MIDLAND PROJECT
DOCKET NOS 50-329, 50-330
RESOLUTION OF NRC CONCERNS RELATED TO
THE STAFFS SAFETY EVALUATION REVIEW
OF THE MIDLAND FIRE PROTECTION PROGRAM
FILE B9.5.1, 0485.11 SERIAL 16795

ENCLOSURE: RESOLUTION OF NRC STAFF CONCERNS
ON THE MIDLAND FIRE PROTECTION PROGRAM

RESOLUTION OF NRC STAFF CONCERNS
OF THE MIDLAND FIRE PROTECTION PROGRAM

MIDLAND UNITS 1 AND 2
DOCKET NO 50-329 AND 50-330
CONSUMERS POWER COMPANY

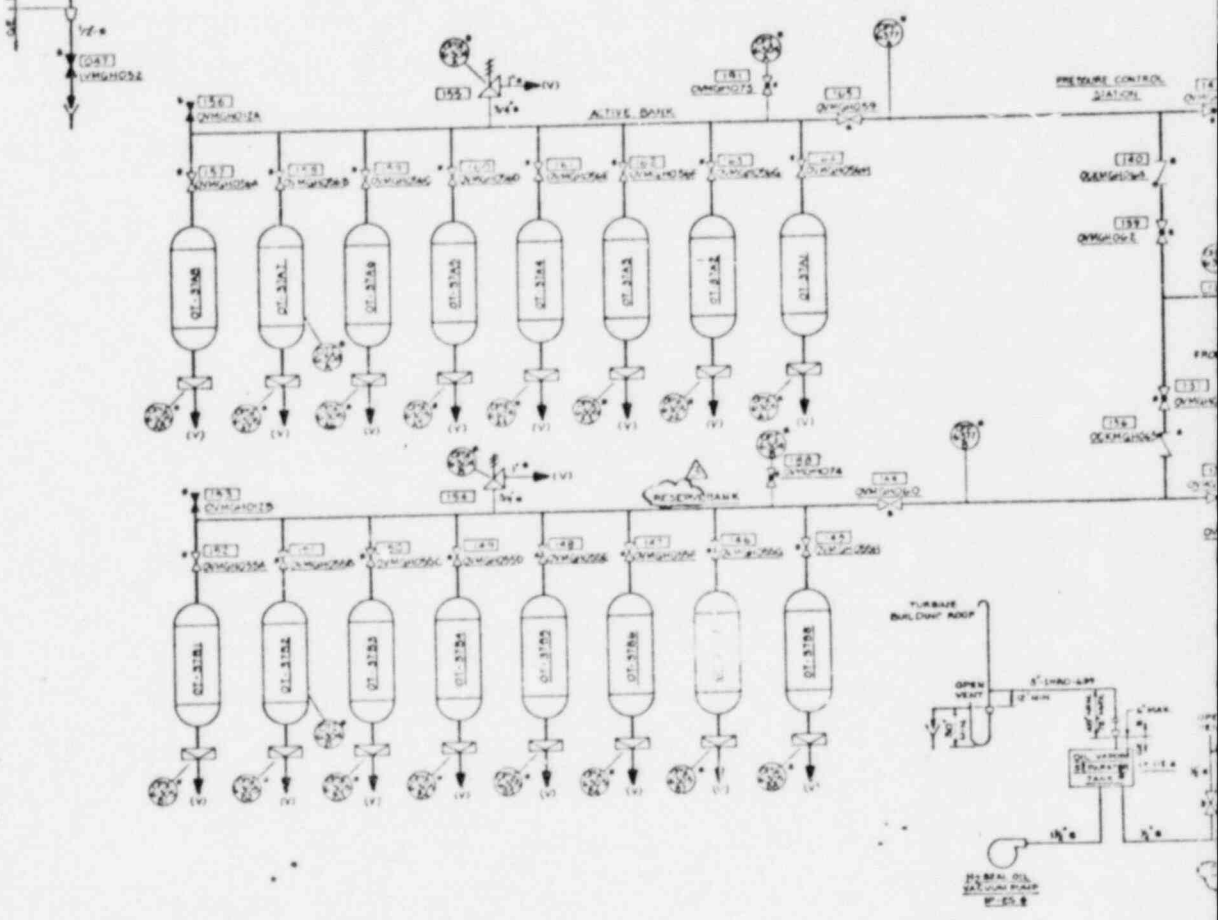
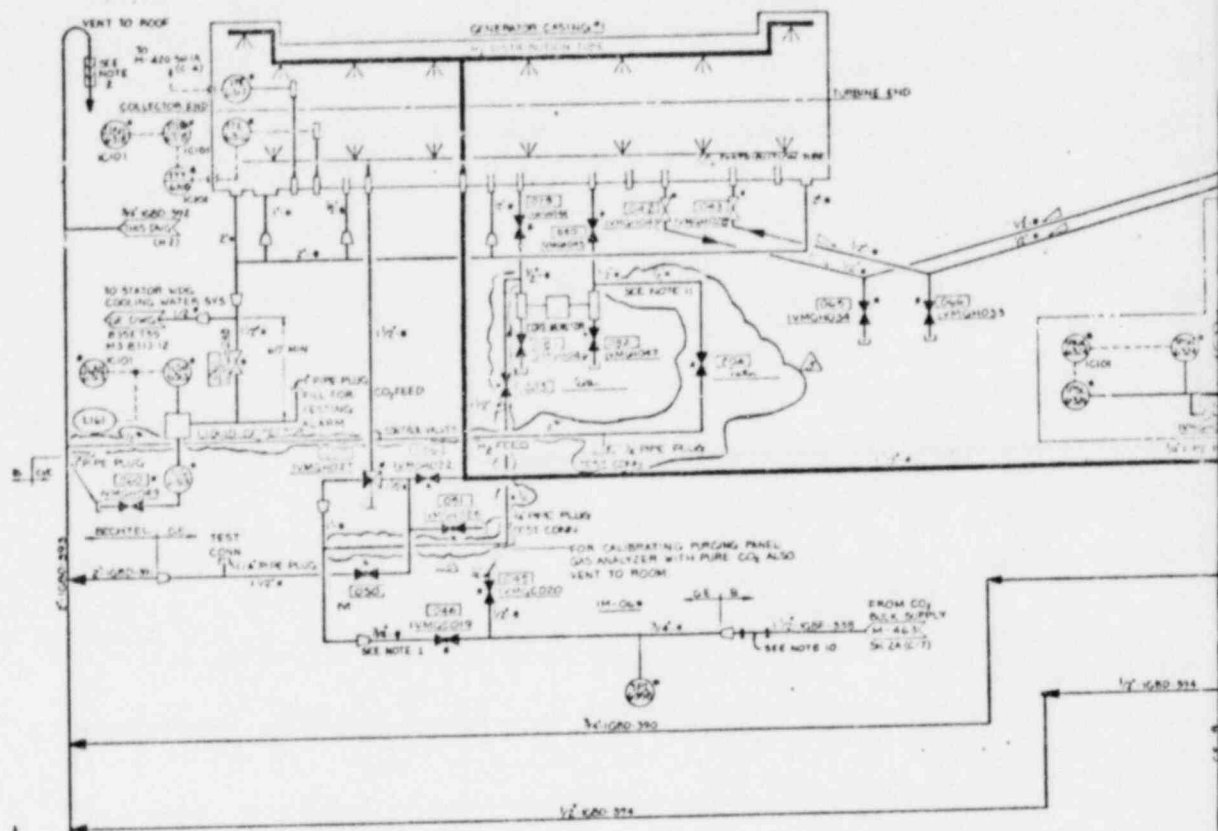
- 1. Auxiliary Building
 - a. Elevation 574' to 614'
 Pipeway - Fire Area 7
 Pipeway - Fire Area 9
 Pipeway - Fire Area 10
 - b. Elevation 659'
 Emergency fuel pool air handling unit room.
 - c. Elevation 685'
 Control room air handling unit room.
- 2. Diesel Generator Building
 - Elevation 634' and 664'
 Floor Area - Fire Area 87
 Floor Area - Fire Area 88
- 3. Service Water Pump Structure
 - Elevation 634' - 6"
 Floor Area - Fire Area 95
 Floor Area - Fire Area 95A
 Floor Area - Fire Area 95B
 Floor Area - Fire Area 95C

report is an elevation view of Fire Areas 8, 10, and 10A. Fire Areas 7, 9 and 9A are a mirrored image of this figure. Fire Areas 9 and 10 extend from elevation 574'-0" to elevation 634'-0". The nearest hose reel to Fire Areas 9 and 10 is located 12' north of Column Line H and 12' east of Column Line 7.4, and is labeled "Hose Reel No 2."

Access to the south portion of Fire Area 10 for manual fire fighting is through Fire Area 10A. Hose Reel No 2 has sufficient length to be used in the southern portion of Fire Area 10 and provide an effective manual hose stream. Due to the verticle wall in the center of the pipe gallery, the northern portion of Fire Area 10 cannot be accessed through this area.

To provide a manual hose stream to Fire Area 10-north, access must be obtained from elevation 614'-0" through Fire Area 8. Draft FSAR Figure 9A-7, plan view of Auxiliary Building at elevation 614'-0", shows Hose Reel No 21 located on Column Line 6.9 and Column Line C. Using this hose reel Fire Area 10-north can be reached through Fire Area 8. The floor separating Fire Area 8 from Fire Area 10 is a grating floor and can be removed to provide access. Therefore, manual fire suppression can be provided for Fire Area 10 even though this area is not readily accessible.

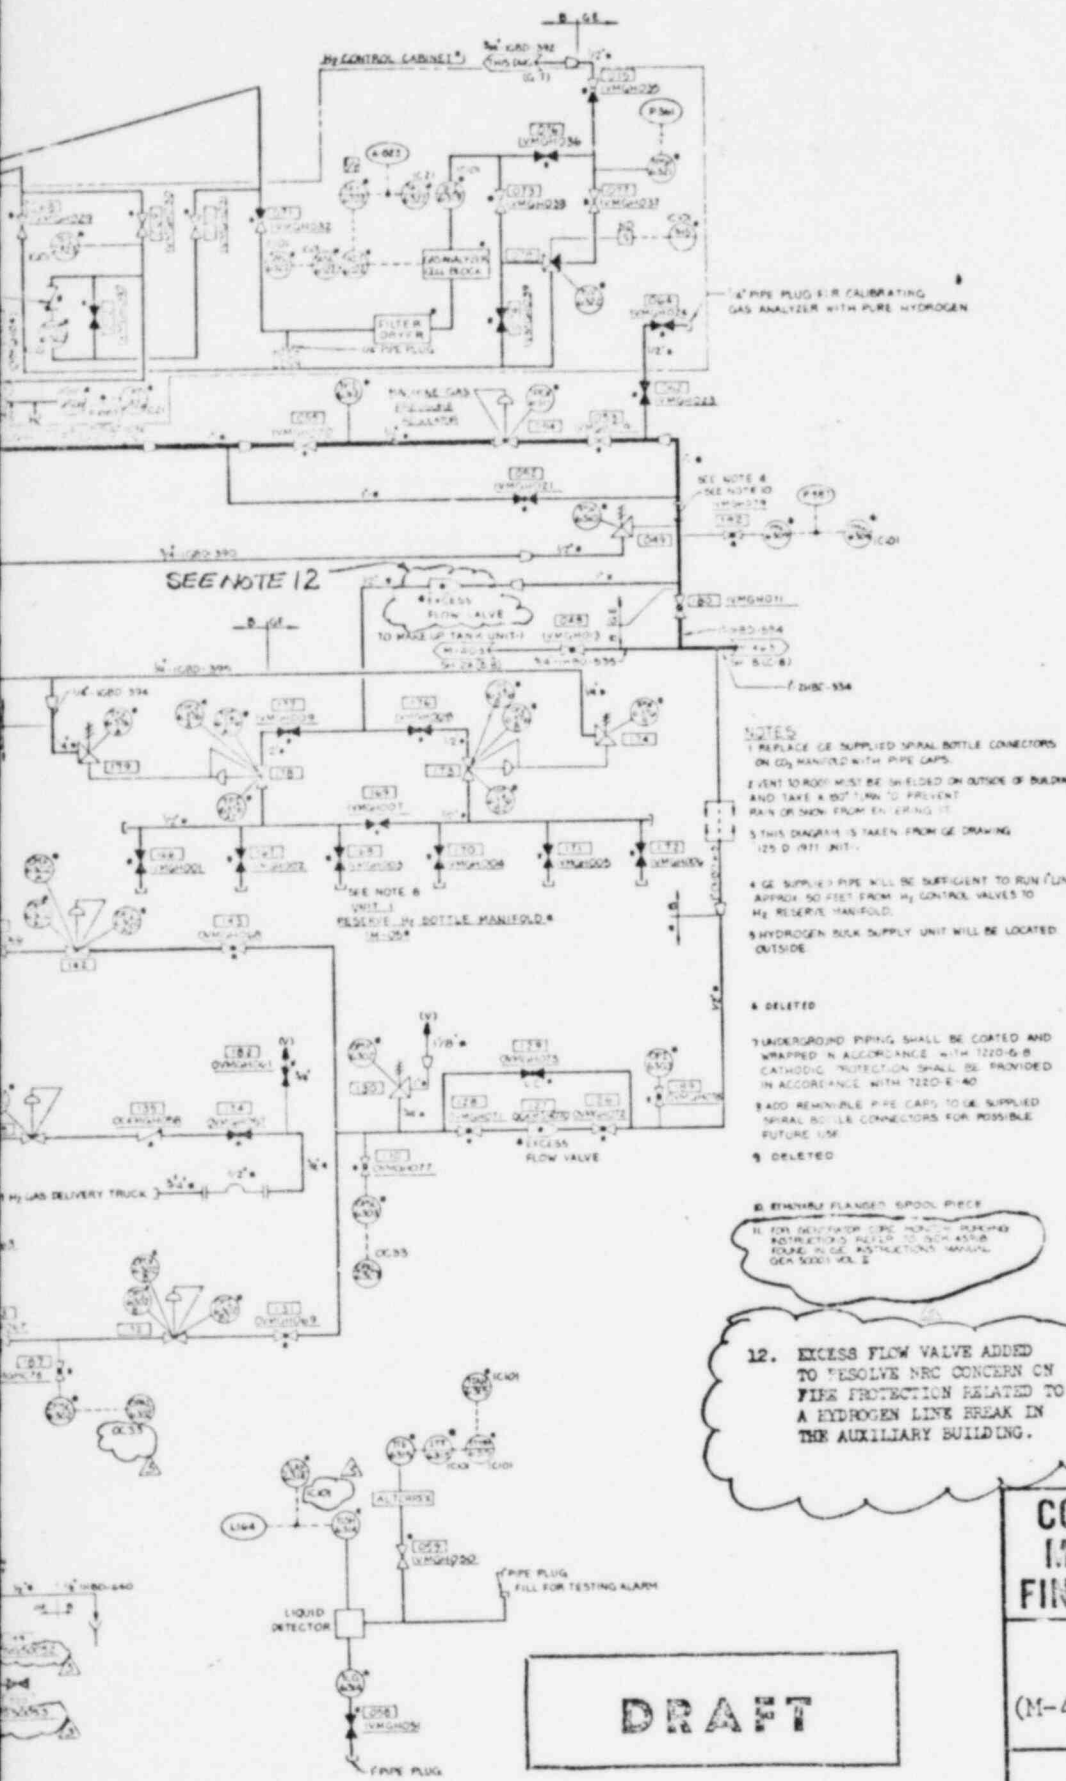
The applicant has not provided adequate information for the Staff to review the hazards posed by the routing of hydrogen piping through safety-related areas. To meet the guidelines of Sections D.2.b of Appendix A to BTP ASB 9.5-1, the staff will require hydrogen piping to be sleeved or to restrict hydrogen flow in case of a line break.

The existing hydrogen system has an excess flow valve located in the main header supply line which is designed to shutdown the flow in the case where flow exceeds 25 SCFM. This excess flow valve is identified as valve QCKMGH 070 on the attached Figure 14, which is the draft FSAR Figure 9.3-41, Sheet 1, and the P&ID for the hydrogen supply system. Calculations show that in the case of a circumferential line break, the hydrogen flow would be about 730 SCFM. In addition a second excess flow valve, such as that indicated on Figure 14, or equivalent protection will be installed to shutdown the flow from the reserve bottled hydrogen source. Normal operating pressure of this system is 90 psig. A low pressure hydrogen alarm located downstream of the excess flow valve will notify the operators. Based on installation of the two excess flow valves indicated on Figure 14, the flow of hydrogen from either the main or reserve source will be cut off in the event of a line break in the auxiliary building.

12. EXCESS FLOW VALVE ADDED TO RESOLVE NRC CONCERN ON FIRE PROTECTION RELATED TO A HYDROGEN LINE BREAK IN THE AUXILIARY BUILDING.
